CITY OF ALBUQUERQUE

**RE: Windrock Fidelity Building
Grading & Drainage Plan
Engineer's Stamp Date: 01/25/23
Hydrology File: J19D055**

DRAINAGE AND TRANSPORTATION INFORMATION SHEET (REV 6/2018)

**WAIVER APPLICATION FROM STORMWATER
QUALITY VOLUME MANAGEMENT ON-SITE**

GRADING PLAN

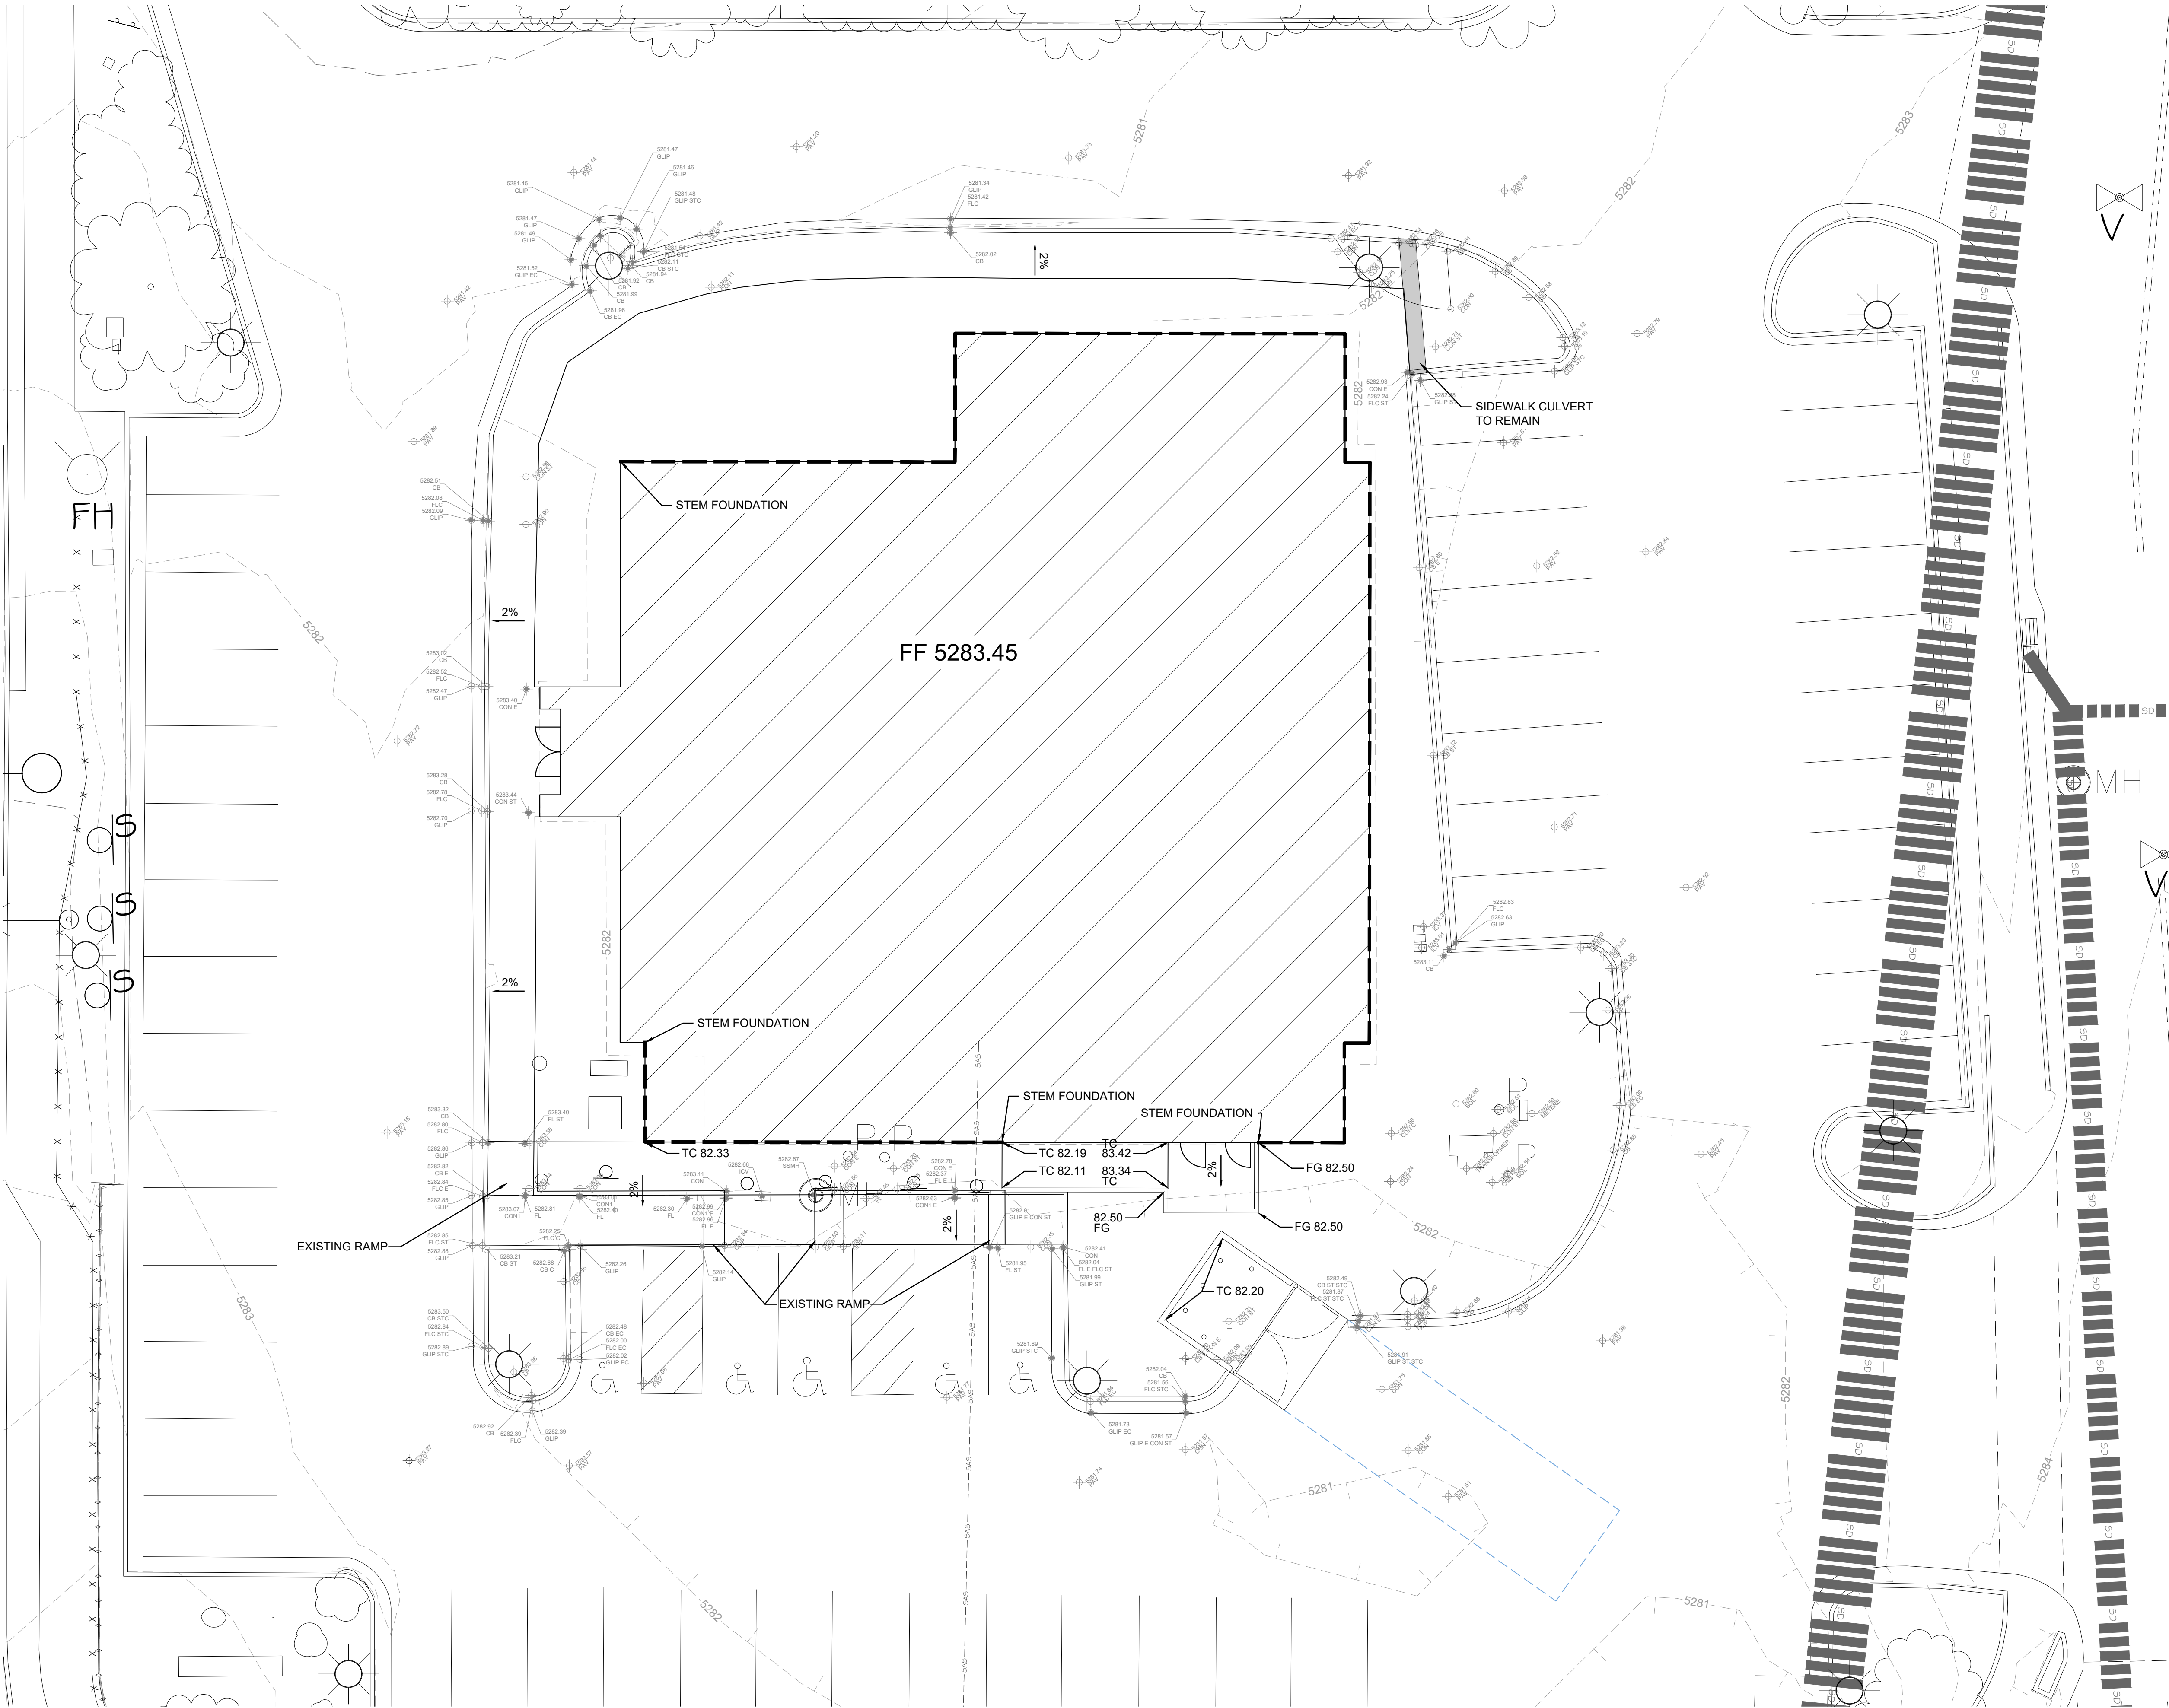
Based upon the information provided in your submittal received 02/24/2023, the Grading & Drainage Plan is approved for Building Permit. Please attach a copy of this approved plan in the construction sets for Building Permit processing along with a copy of this letter.

1. Engineer's Certification, per the DPM Part 6-14 (F): *Engineer's Certification Checklist For Non-Subdivision* is required.
2. Please pay the Payment-in-Lieu of \$ **6,570.40** by emailing the attached approved Waiver Application from Stormwater Quality Volume Management On-site to PLNDRS@cabq.gov. Once this is received, a receipt will then produce and email back. This will have to be paid in person at the Treasury and please provide Hydrology proof of payment.
